SCOPE OF PROJECT CHANGES:

PERMIT DRAWINGS

CLARKSON RESIDENCE

1 PROPOSED SITE PLAN
1" = 10'-0"

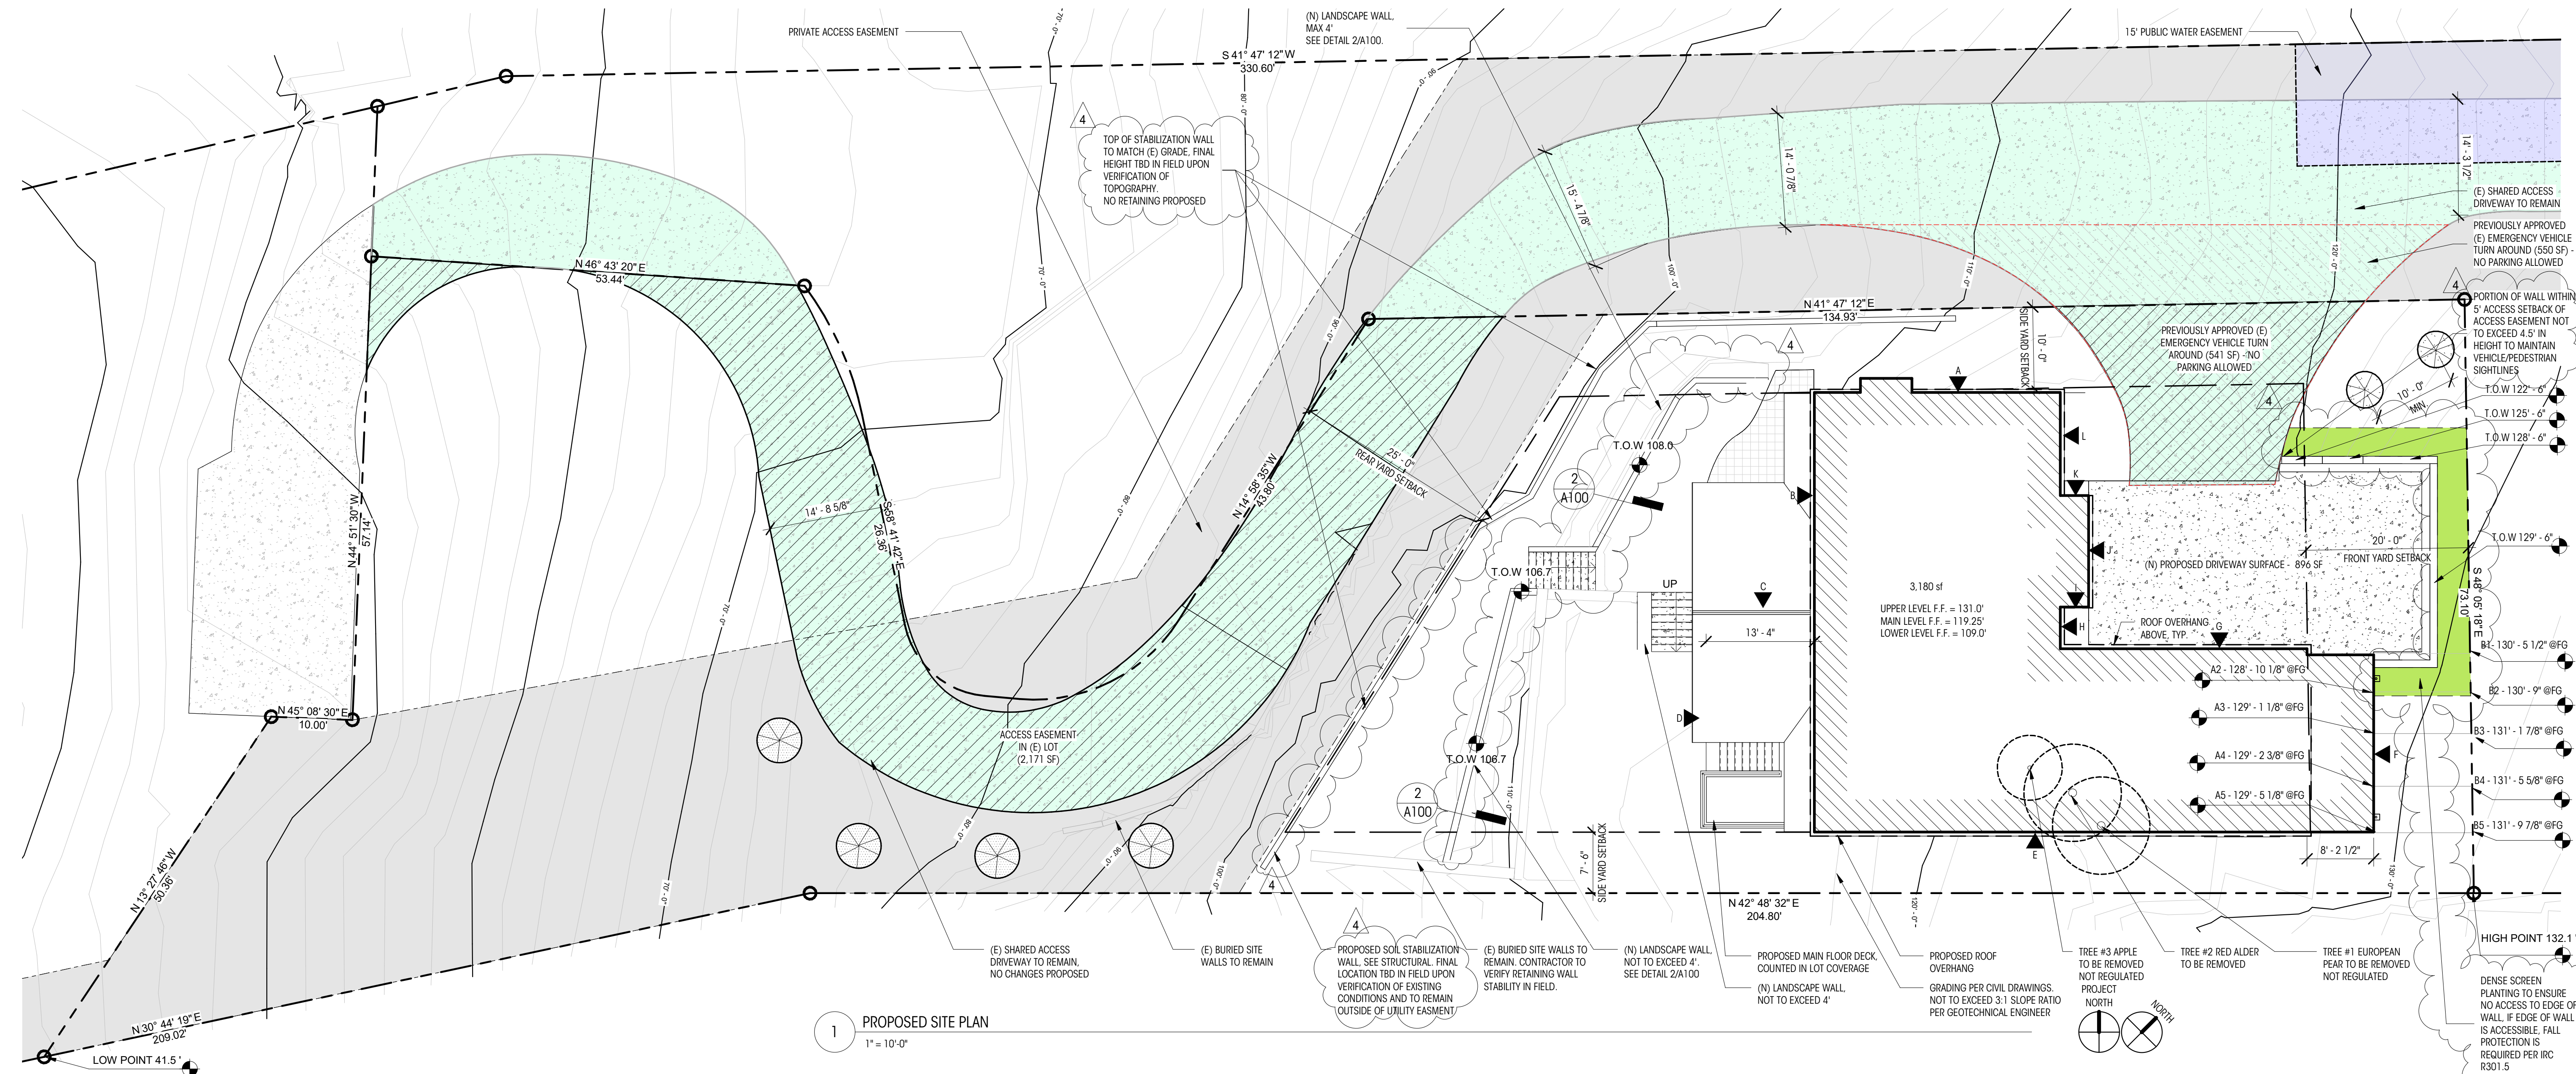
- NO CHANGE TO ROOF OVERHANGS AT SETBACKS
- NO CHANGE TO VARIABLE SIDE YARD SETBACKS
- NO CHANGE DOWNHILL SLOPE GRADE OR RIDGE HEIGHT
- EXTEND GARAGE EAST INTO FRONT YARD SETBACK AS ALLOWED BY CODE 19.02.040.D

- FRONT YARD ENCROACHMENT CALCULATIONS ADDED
- SHIFT OF PARKING RETAINING WALLS TO NORTH AND SOUTH
- CHANGE ROOF OF AND EXTEND WESTERN PATIO TO THE WEST AND SOUTH

- CHANGE IN SOIL RETENTION WALL, PREVIOUSLY AS PART OF FOUNDATION SYSTEM, NOW MOVED TO WESTERN YARD ADJACENT TO ROAD IN ORDER TO ALLOW FOR LANDSCAPE WORK

- REVISED LEGAL DESCRIPTION AS A RESULT OF PROPERTY SALE
- CHANGE TO LOT COVERAGE AS A RESULT OF SHIFTED PARKING RETAINING & EXTENDED COVERED DECK
- CHANGES TO HARDSCAPE CALCULATIONS AS A RESULT OF SOIL STABILIZATION WALL, PATIO EXTENSION AND SITE STAIRS

- CHANGES TO GFA AS A RESULT OF EXTENDED GARAGE AND EXTENDED COVERED DECK
- REVISED LOCATION TO REPLACEMENT TREES
- CHANGE TO ABE AS A RESULT OF EXTENDED GARAGE AND EXTENDED COVERED DECK

- GRAPHICS/PATTERNS/HATCHES HAVE BEEN COORDINATED FOR CONSISTENCY
- MEETS AND BOUNDS ADDED TO ALL PROPERTY LINES

EXCAVATION PLAN

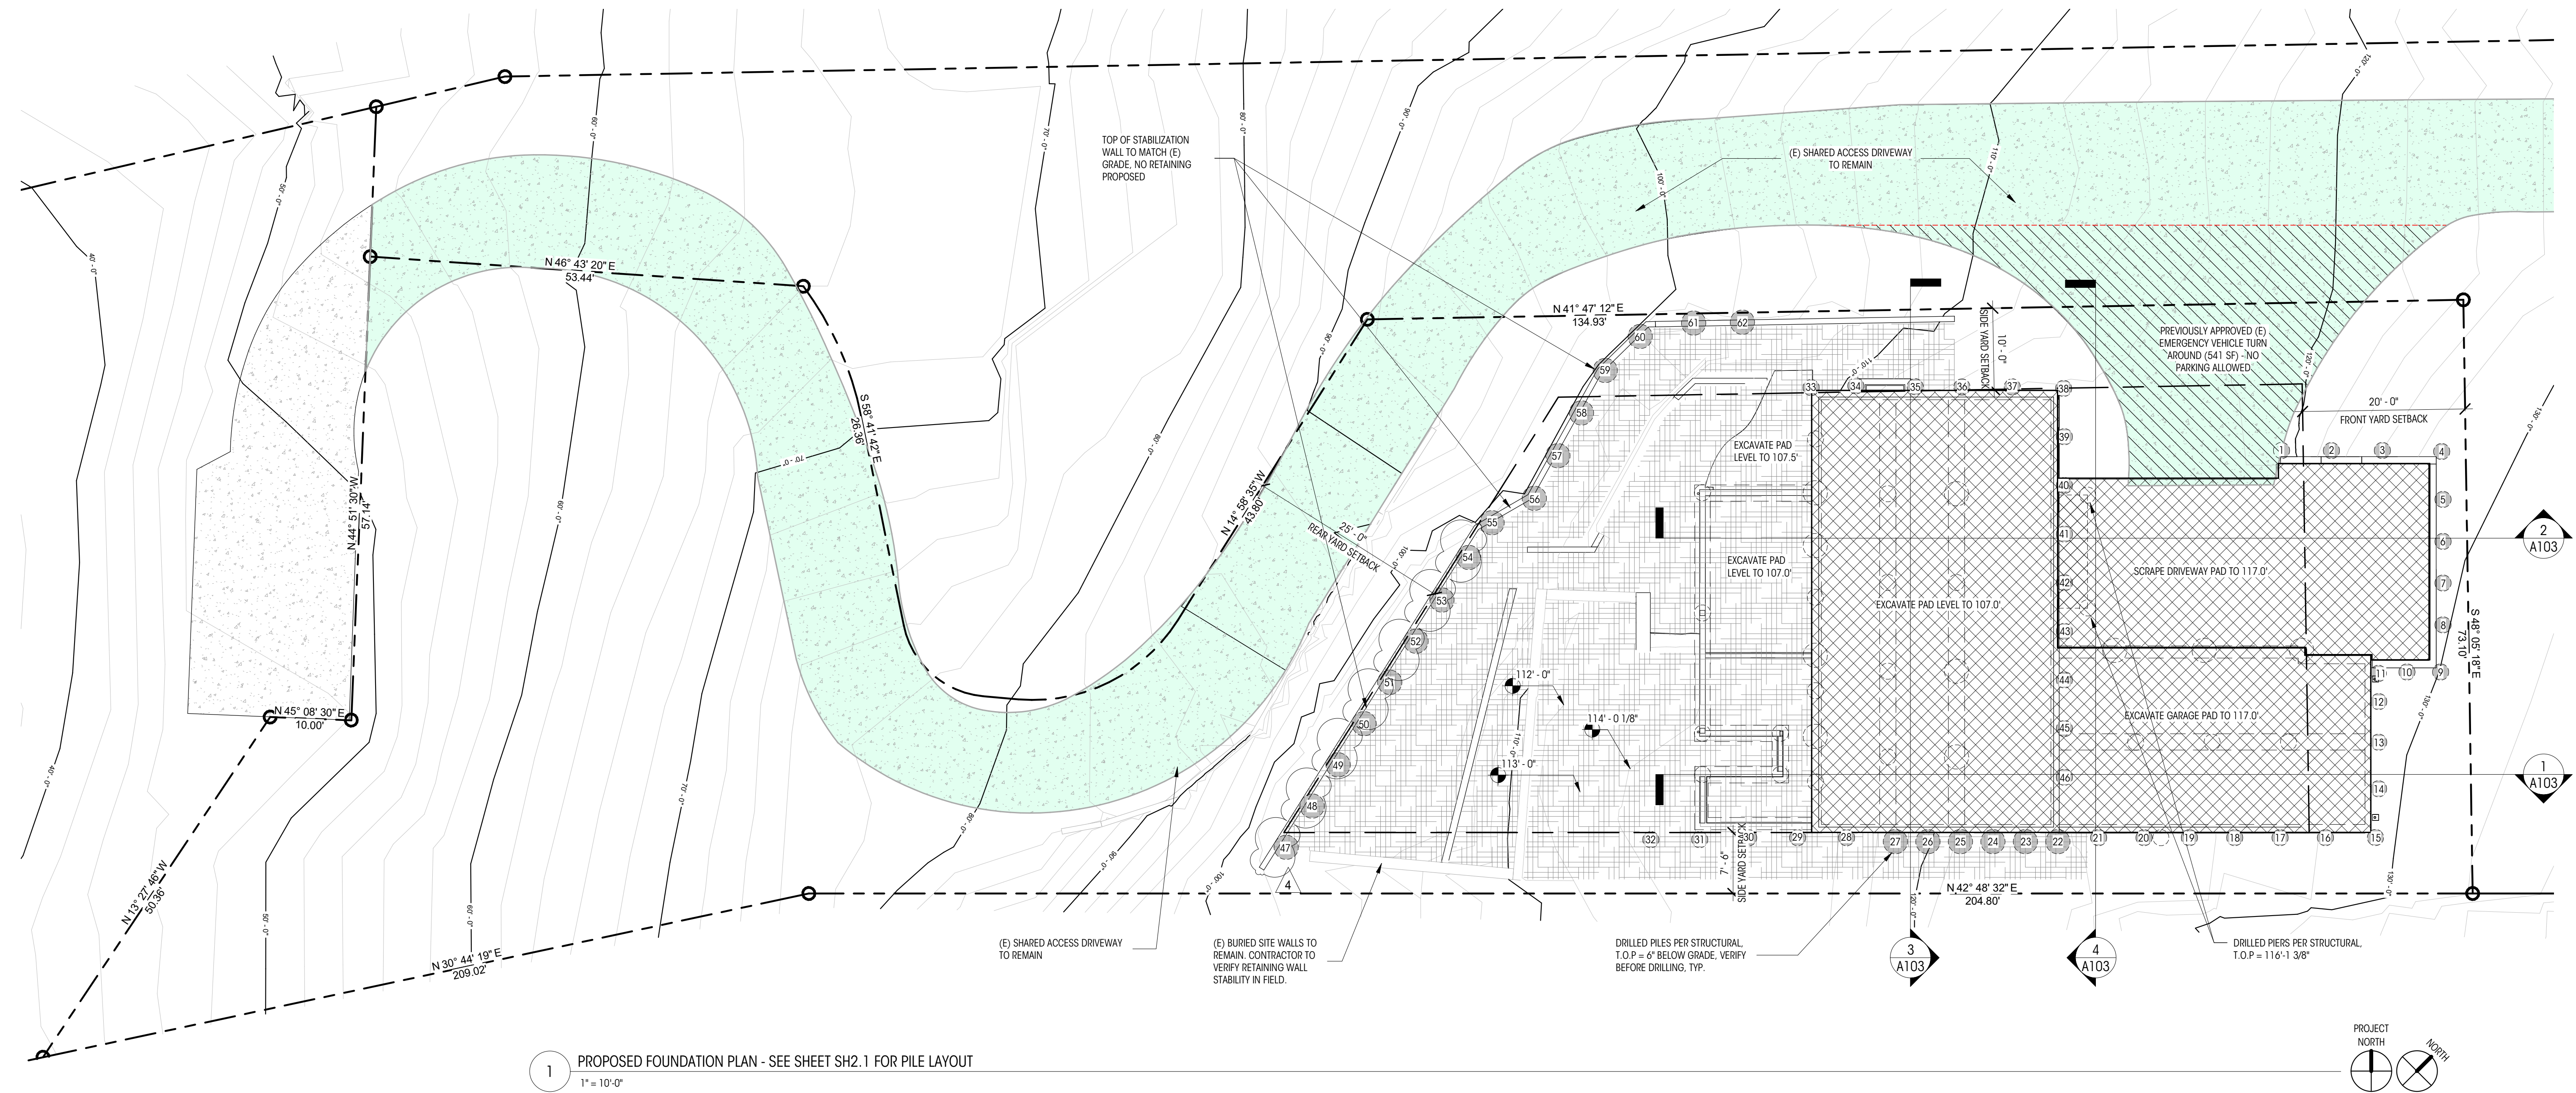
- CHANGE IN SOIL RETENTION WALL: PREVIOUSLY AS PART OF THE FOUNDATION SYSTEM, NOW MOVED TO WESTERN YARD ADJACENT TO ROAD IN ORDER TO ALLOW FOR LANDSCAPE WORK
- REVISED FOUNDATION AS A RESULT OF SOIL STABILIZATION WALL LOCATION MOVE.
- LEVEL CHANGES: DRIVEWAY & GARAGE LEVEL DROP BY 15"; BASEMENT LEVEL DROP BY 12".
- GRAPHICS/PATTERNS/HATCHES HAVE BEEN COORDINATED FOR CONSISTENCY
- ADDITIONAL GRADING PROPOSED AS A RESULT OF THE ADDED LANDSCAPE WALLS.
